# UNITED STATES PATENT AND TRADEMARK OFFICE

APPLICATION NO.	FILING DATE	FIRST NAMED INVENTOR	ATTORNEY DOCKET NO.	CONFIRMATION NO.
09/986,614	11/09/2001	Masaki Shimada	02860.0695	5939

# Office Action Summary

## **DETAILED ACTION**

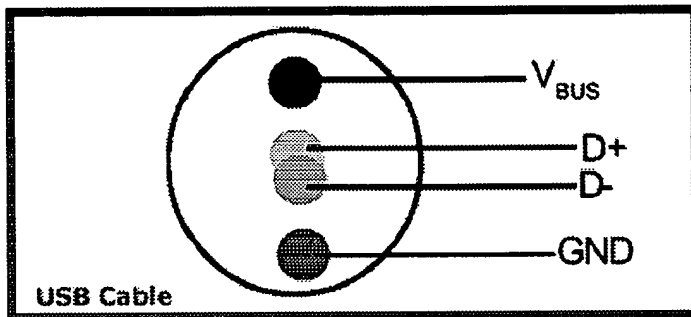
supplied between the device (50) and the external device (host device 10/ upstream host or camera 54), wherein the interface cable also includes the data communication path and the power-supplying path (the USB devices of Hannah must be in full compliance with the USB specification; wherein the USB cable transfers both power and data. A typical USB cable is shown below:

; wherein Vbus is 5V at the source and a twisted wire pair for data); a data-storing unit (the storage medium of VCR 50) to store the data sent from the interfacing circuit; and a plurality of interface connecting ports (privileged upstream port or host port and hub port 56) serving as input/output terminals of the interfacing circuit, wherein the interface cable can be connected to one of the interface connecting ports.

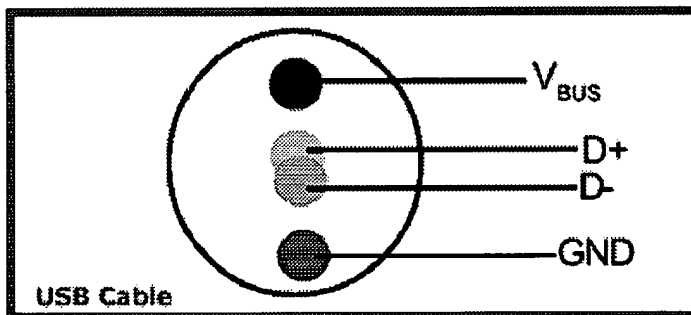
With regard to claim 1, 954 discloses a device for storing data (30), comprising: an interfacing circuit (USB interface) that includes a data communication path through which the data can be bilaterally communicated between the device (30) and an external device (20), which is coupled to the device (30) with an interface cable (it is inherent that a USB cable is need to provide USB connections between devices or nodes), and a power-supplying path through which a power current can be bilaterally supplied between the device (30) and the external device (20), wherein the interface cable also includes the data communication path and the power-supplying path (the USB devices of 954 must be in full compliance with the USB specification; wherein the USB cable transfers both power and data. A typical USB cable is shown below:

; wherein Vbus is 5V at the source and a twisted wire pair for data); a data-storing unit (FDD 21) to store the data sent from the interfacing circuit; and a plurality of interface connecting ports (ports for external device 20, keyboard 3 and mouse 4)
